From: [Ross Mollenhauer](#)
To: [Matt Hammerstein](#)
Cc: [Emily Gluckin](#); [Dave DeGrandpre](#); [Kody Swartz](#); [Spencer Woith](#); [Tony Hilliard](#); [Logan McInnis](#); [Andy Schultz](#)
Subject: RE: Mcnett Flats Subdivision - First Agency Sufficiency Review
Date: Wednesday, September 23, 2020 4:38:01 PM
Attachments: [Figure 4 Mullan WW.PDF](#)
[image002.png](#)

From: Matt Hammerstein <matt@woitheng.com>
Sent: Tuesday, September 8, 2020 11:03 AM
To: Matt Hammerstein <matt@woitheng.com>
Cc: Emily Gluckin <GluckinE@ci.missoula.mt.us>; Dave DeGrandpre <DeGrandpreD@ci.missoula.mt.us>; Kody Swartz <kody@woitheng.com>; Spencer Woith <spencer@woitheng.com>; Tony Hilliard <tony@woitheng.com>
Subject: Mcnett Flats Subdivision - First Agency Sufficiency Review

Figure 4. New Sewer Piping Preliminary Layout

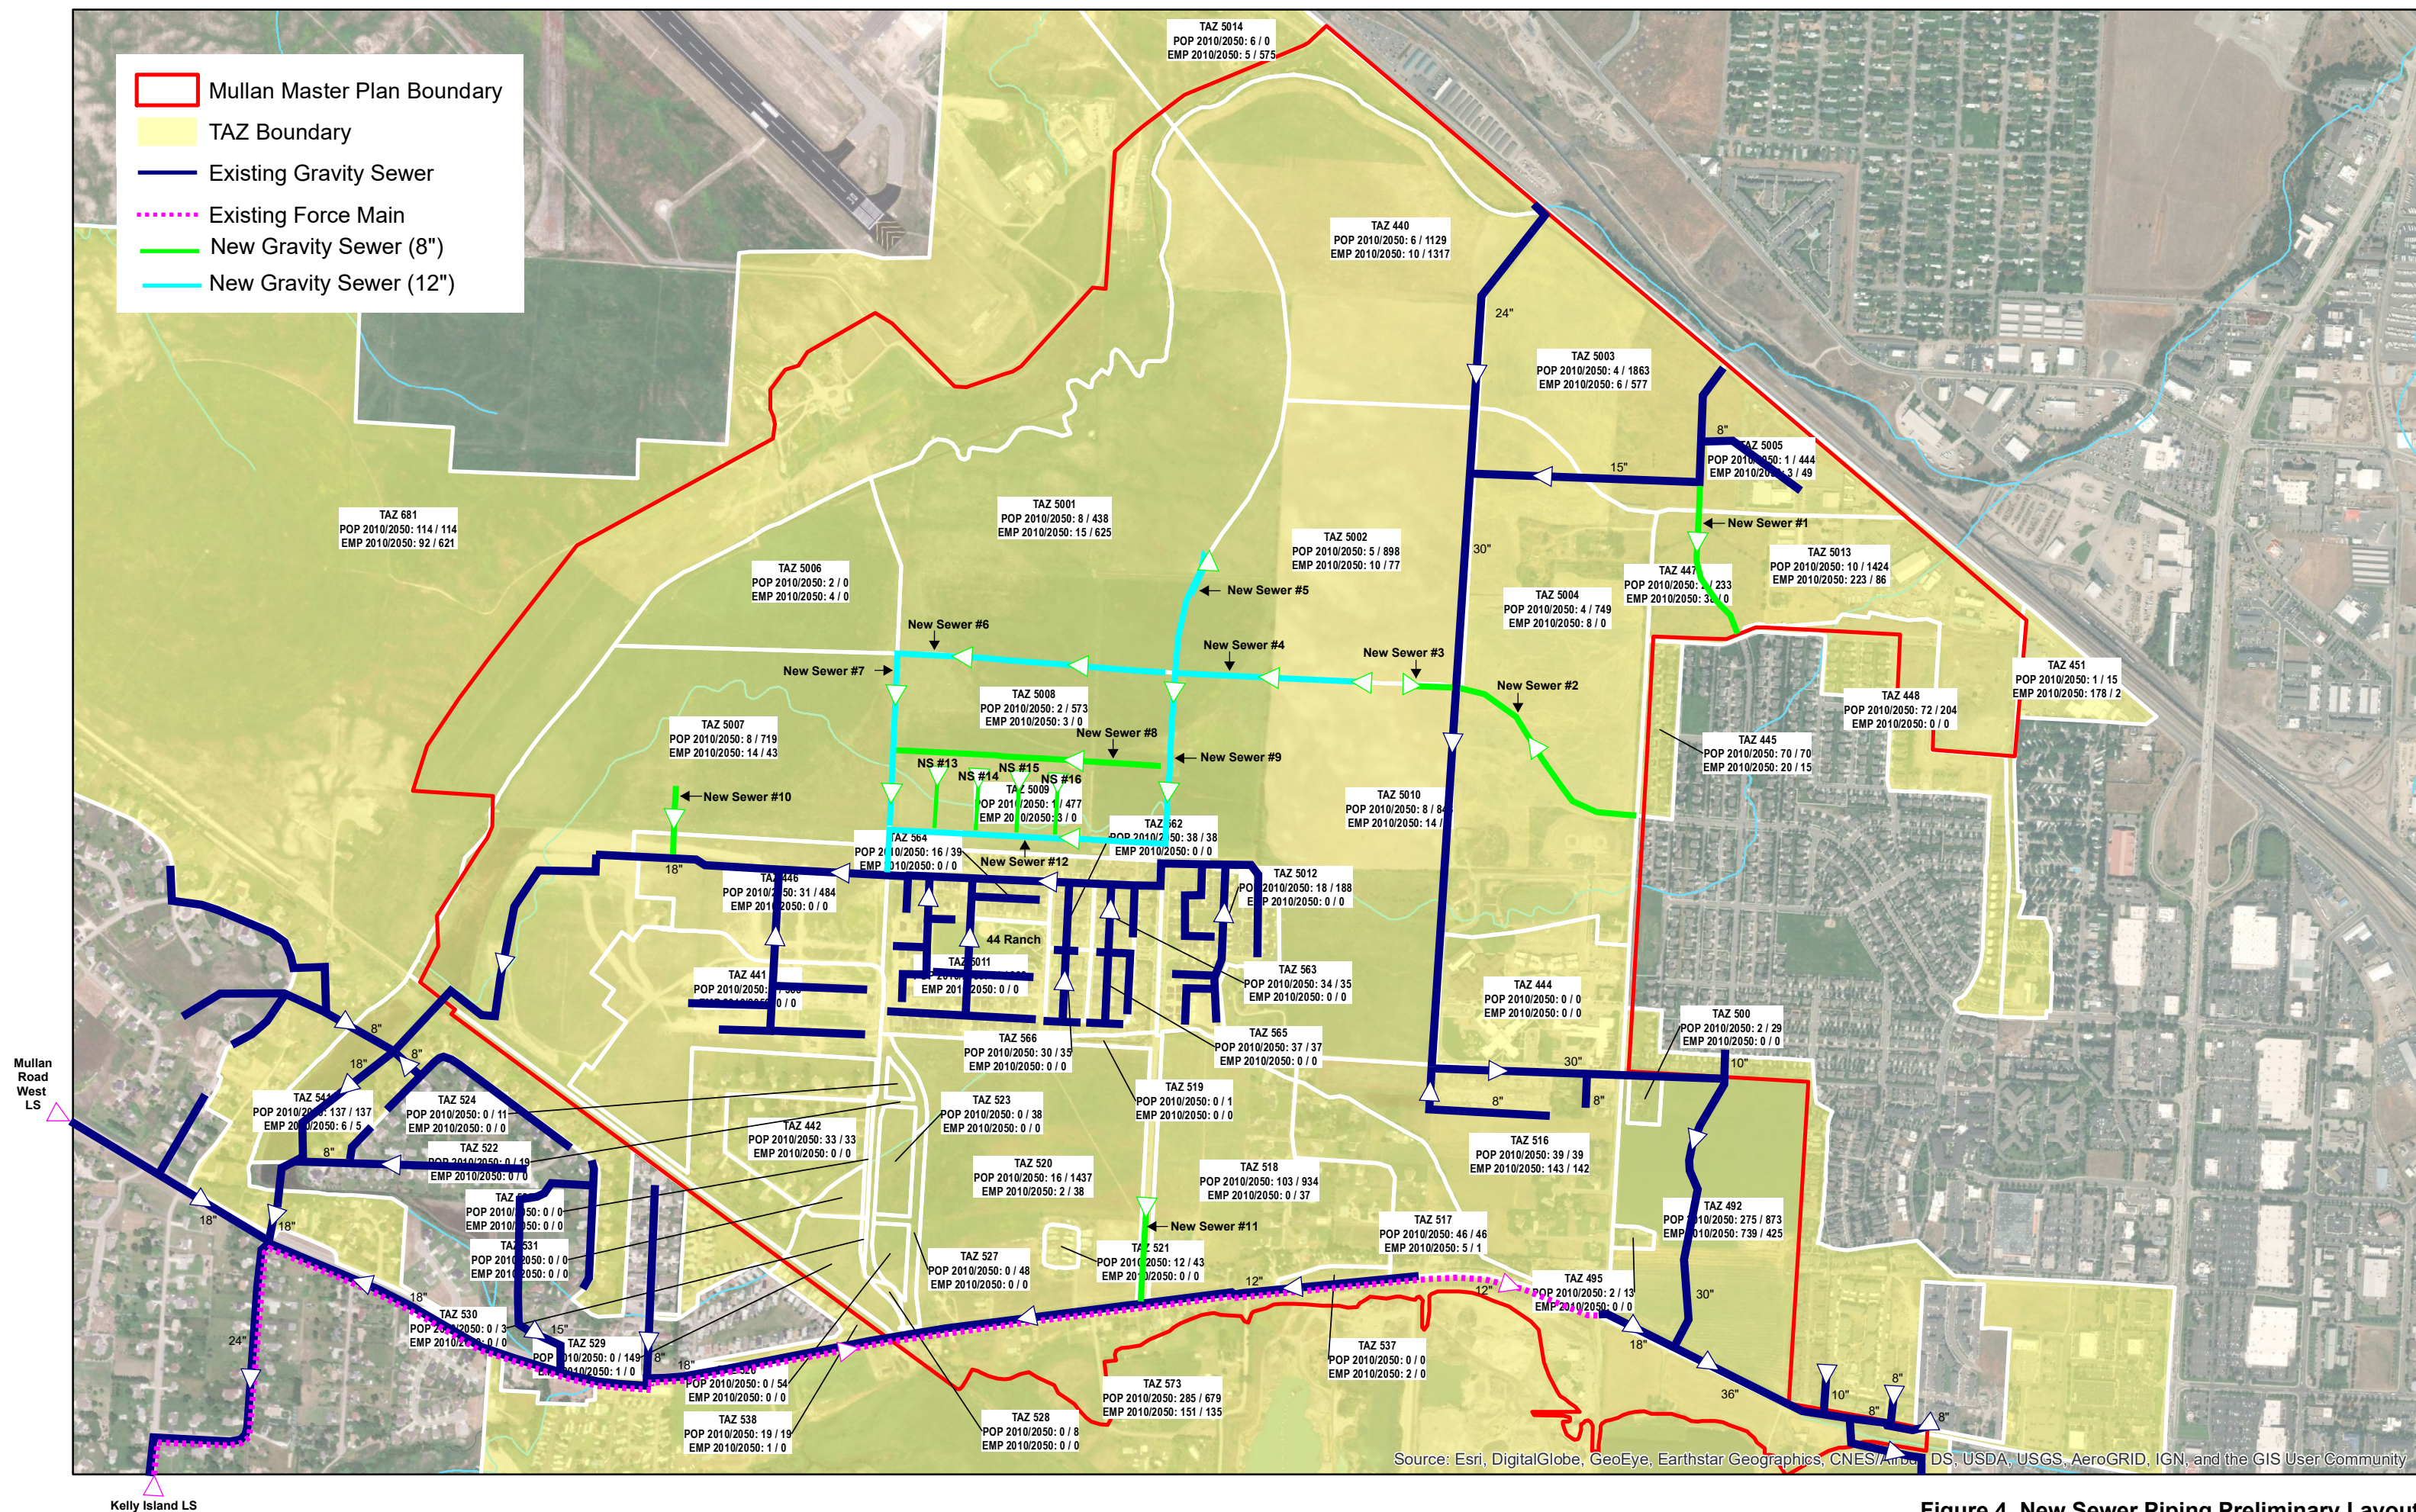
- HDR/DJA have been running the sewer model for us to estimate the necessary sewer main sizes in this area. I don't know that their results are final but the last version I have seen is attached here. As you can see it shows a 12" sewer main running north in George Elmer and flowing west into Remington Flats at some point. Therefore I would ask that all of Sewer Main A be upsized to 12" in size. It's true that it could just be upsized in George Elmer only but without knowing how the land to the north will develop, I'd rather give us 2 streets (George Elmer and Old Ranch Rd) as corridors for our 12" backbone to expand. Maintain minimum grade.
